**From:** [REDACTED]  
**To:** [Norfolk Boreas](#)  
**Subject:** Deadline 14 Submission  
**Date:** 25 August 2020 14:47:01  
**Attachments:** [Boreas Plans Monday 24 08 20.doc](#)  
[Windfarm plans.zip](#)

After having these printed, on review I am still not assured of the safety of the proposed HIS. I have responded with further considerations and questions to Vattenfall today and attach all for your reference. I would strongly draw your attention to drawing TP -PB5640-DR066

PROJECT  
**NORFOLK BOREAS  
 OFFSHORE WIND FARM**

DRAWN	RNE	CHECKED	ADR	APPROVED	ADR
DATE	03.01.2020	SCALE AT A1	1:500	CLIENTS REF.	
DRAWING No.	TP-PB5640-DR017				REVISION
CLIENT DWG No.					F3.0

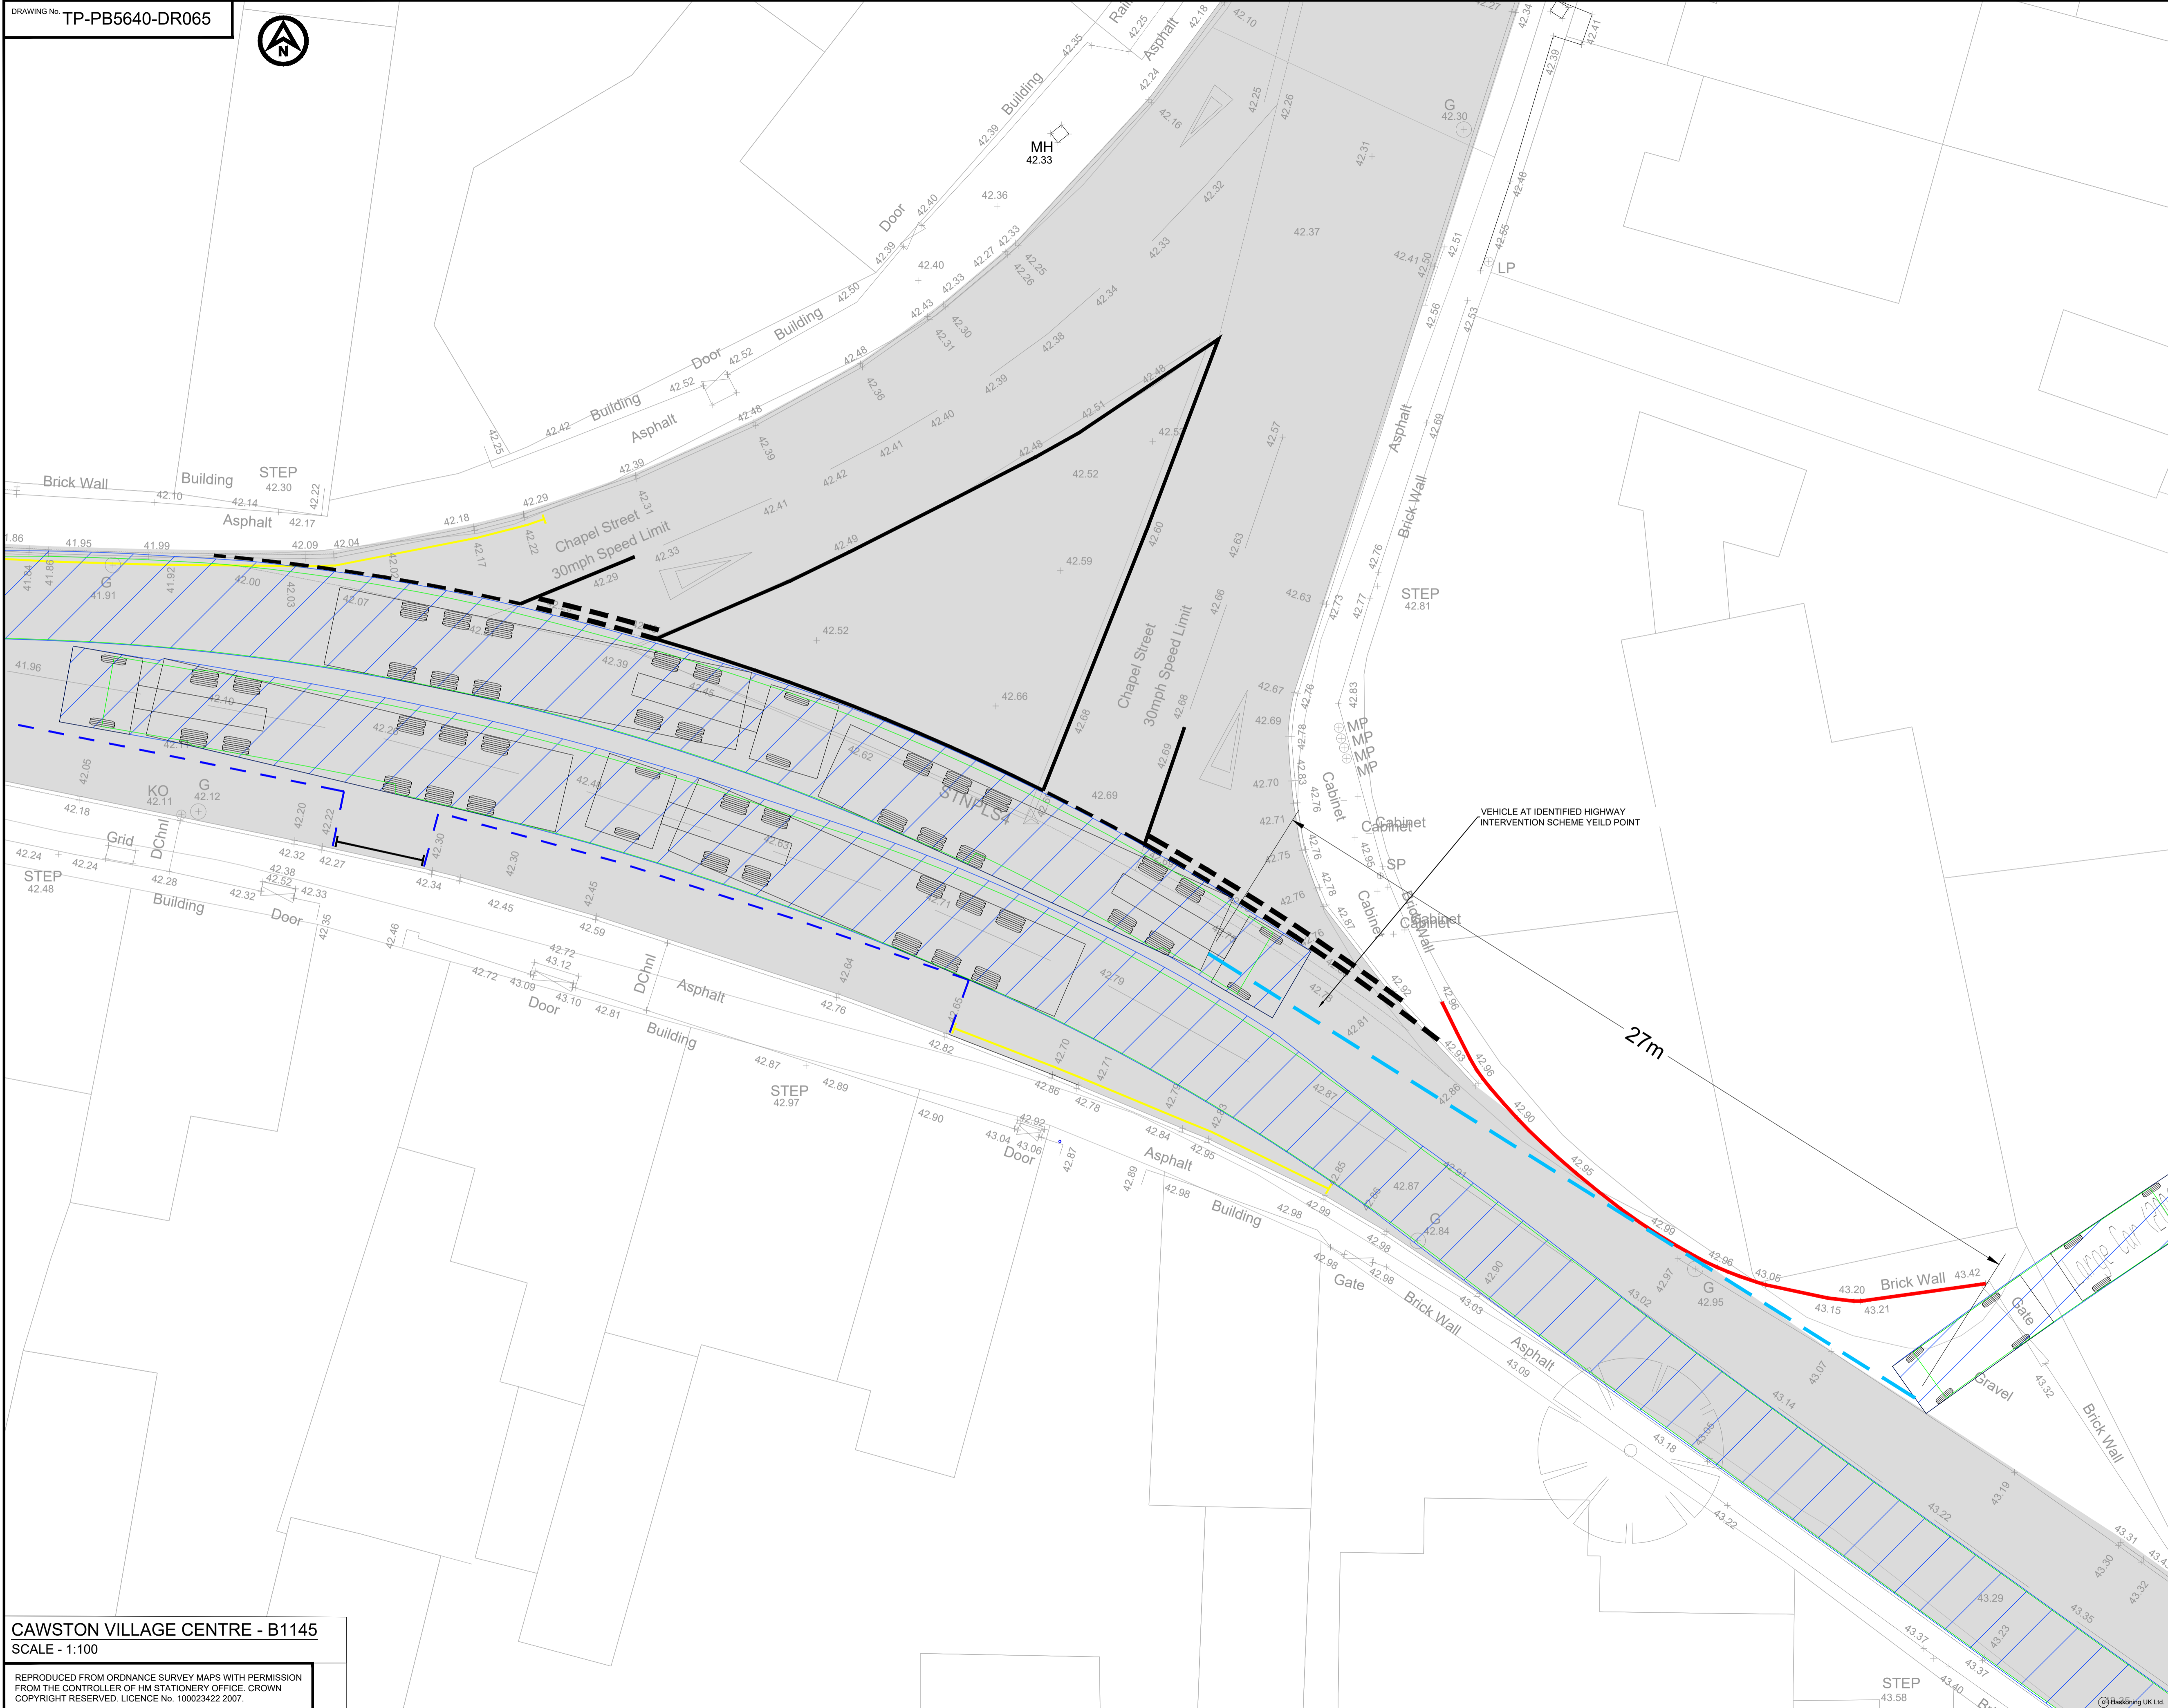
Plans at 1:500 are difficult to view and cannot be accurately scaled without the CAD package that they are drafted on. Marked visibility lines here pass over parking bays and skim wall/ pavement edges, indicating clear visibility distances that cannot be accomplished without eliminating all other traffic or parking. The scheme relies heavily on a sequence of vehicles waiting for opposing ones in a known pattern. Driver compliance may make this a possibility for the HGV drivers but you are proposing this for a village which already has a difficult road because of width and bends. There is everyday traffic in this scenario and they will not understand the dance. There are no get out points in the scheme as drawn. In scenarios of traffic conflict how is it eased?

This drawing shows the yield point at the eastern end of the village, this is past the Norwich Road, the view to exit that road onto the main traffic route is again difficult, has consideration been taken as to how traffic enters and exits here, their situation is somewhat similar to that of exiting my drive and will be coming between two yield points.

DRAWN	RNE	CHECKED	ADR	APPROVED	ADR
DATE	29.07.2020	SCALE AT A1	1:100	CLIENTS REF.	
DRAWING No.	TP-PB5640-DR065	REVISION			
CLIENT DWG No.					F1.0

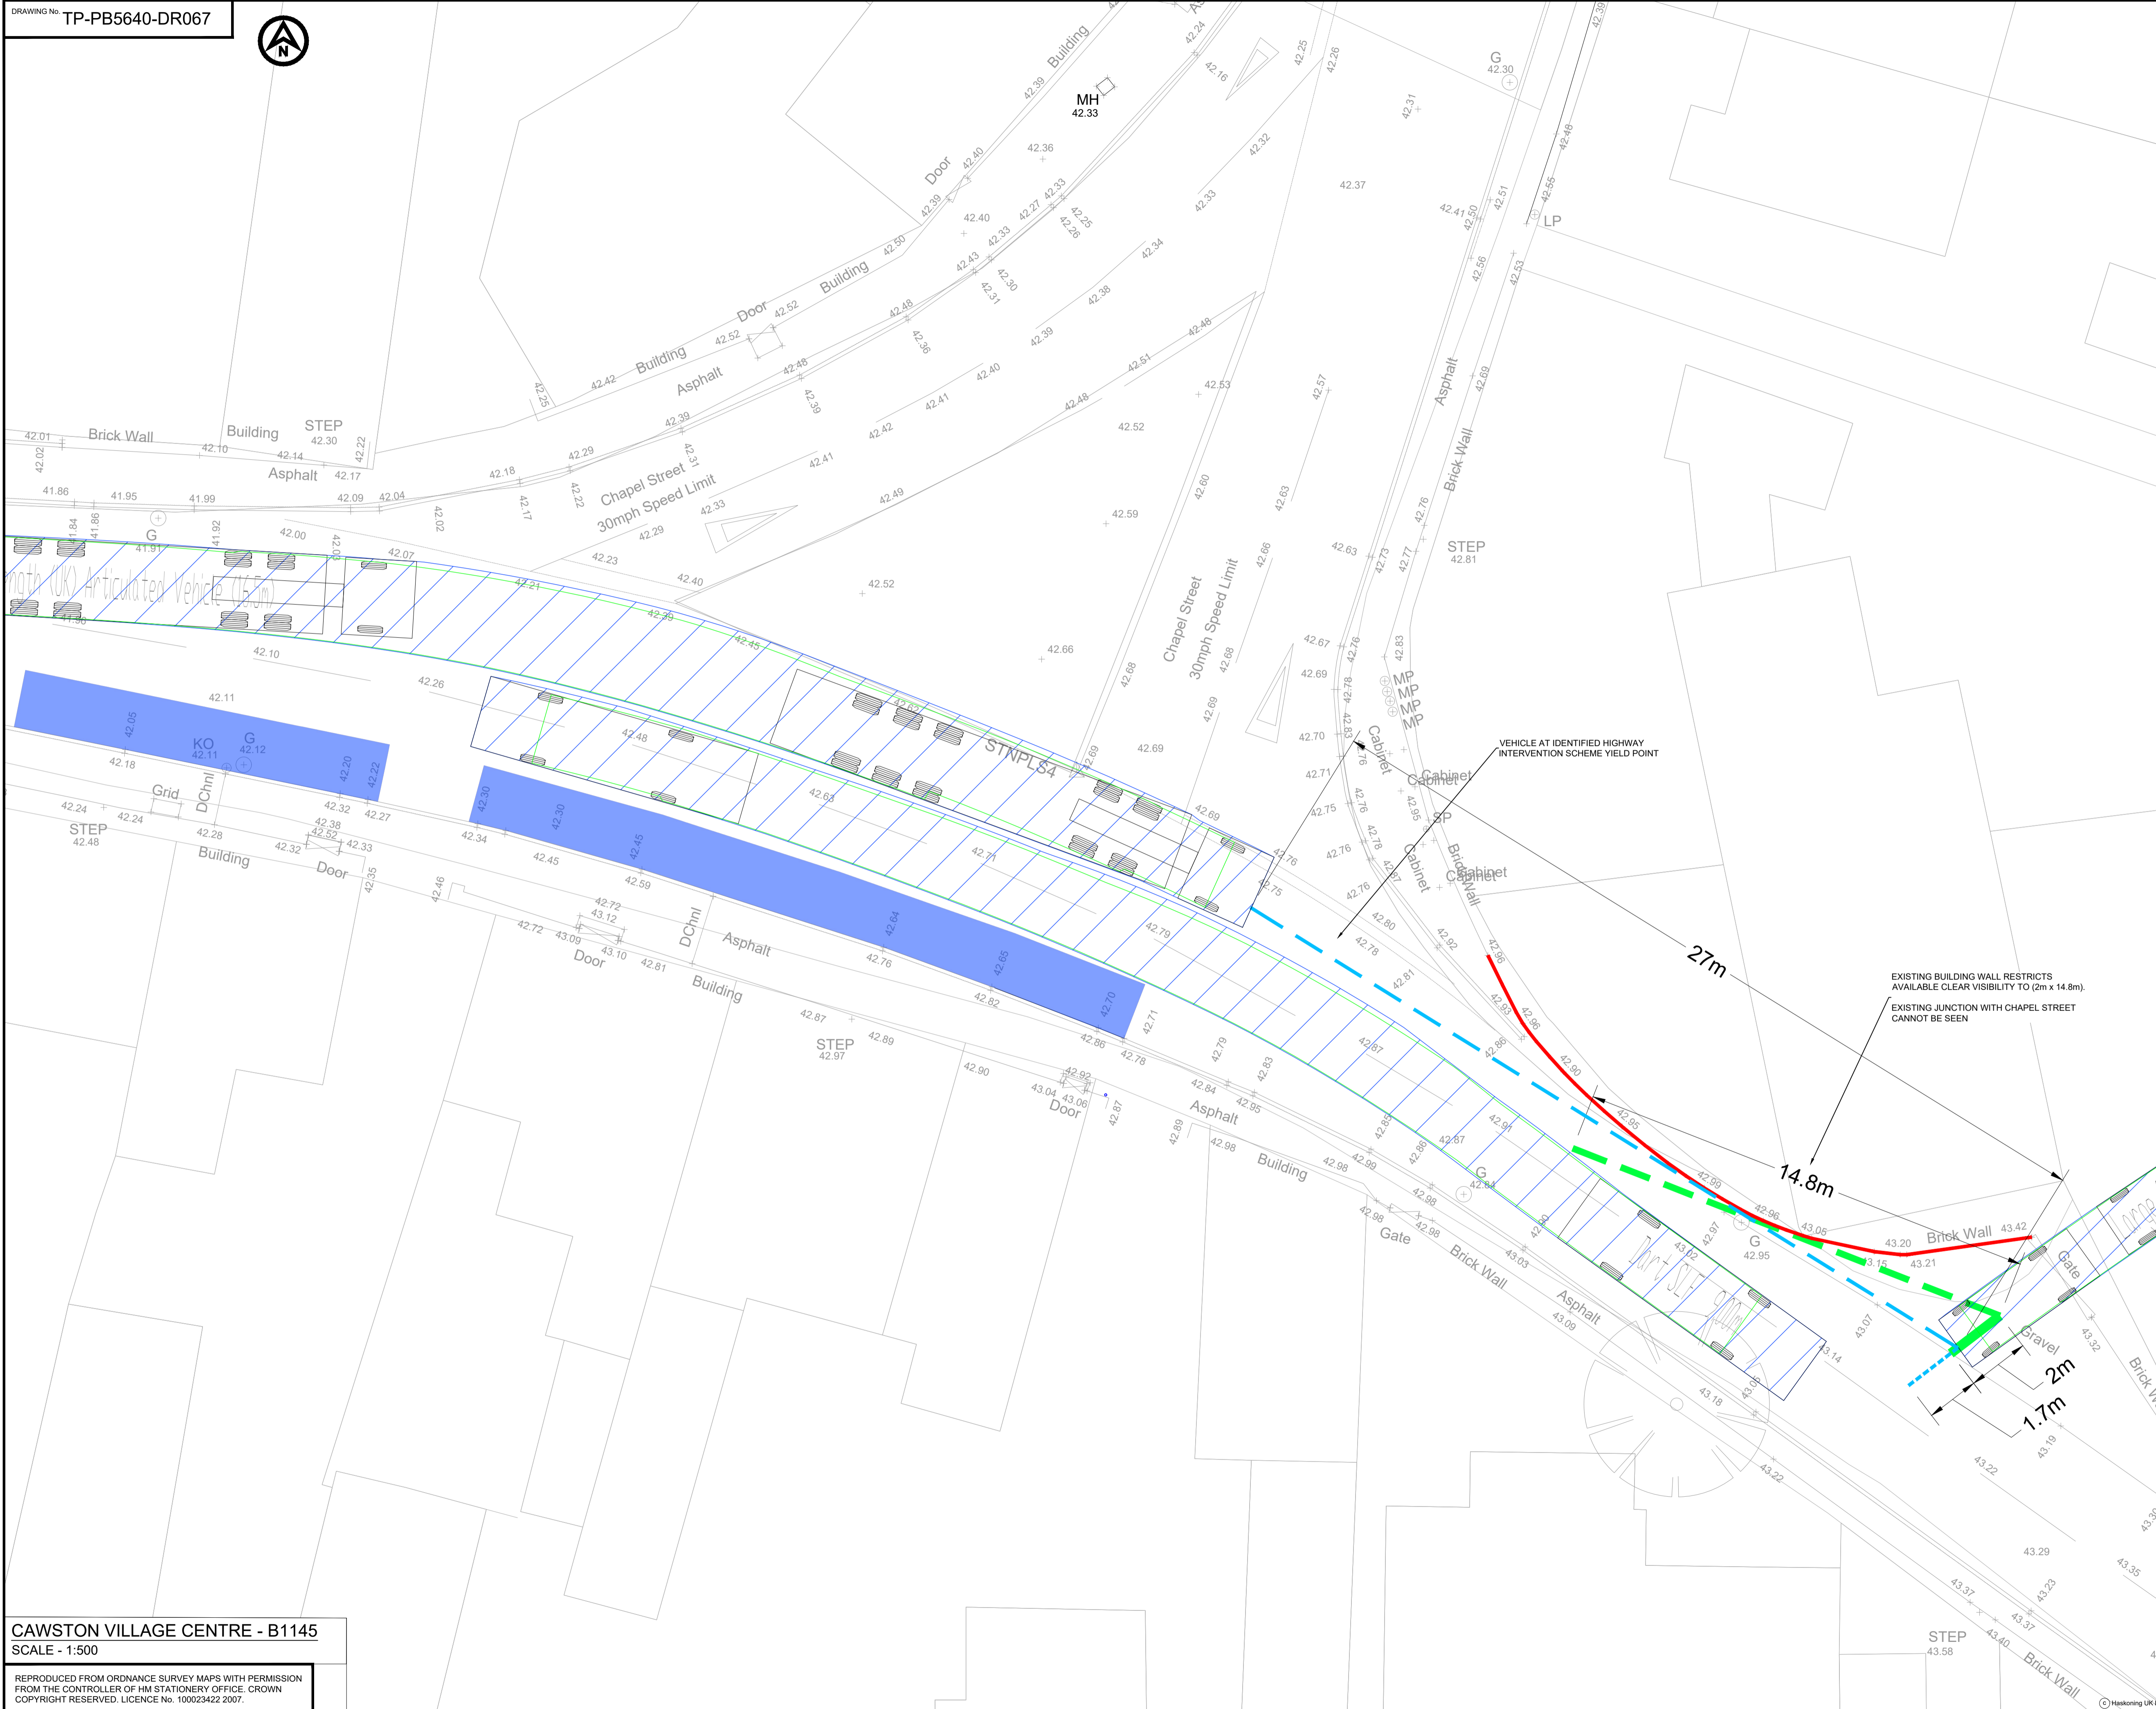
In the technical notes your bullet point for this drawing it states a 27metre requisite forward visibility is required for the HGV to see a vehicle leaving our driveway. That measurement seems to be taken from the trailer, rather than the cab to the very corner sighting of my vehicle. From the drivers position to an actual visual of the car (when that driver is actually focused on looking for another HGV some 90m down the road) will be significantly less than that visibility requisite and stopping distance – and as drawn I am totally reliant on his/ her visual of me and stopping, I have no sight line of the vehicle at that time.

On this drawing the yield point is shown to completely block the entry/ exit to Chapel Street. An immediate log jam scenario. Again I ask has anyone spoken to the businesses on Chapel Street, how many winery lorries have to make that turn daily? Are the yielding HGVs going to reverse to allow access? Could they?
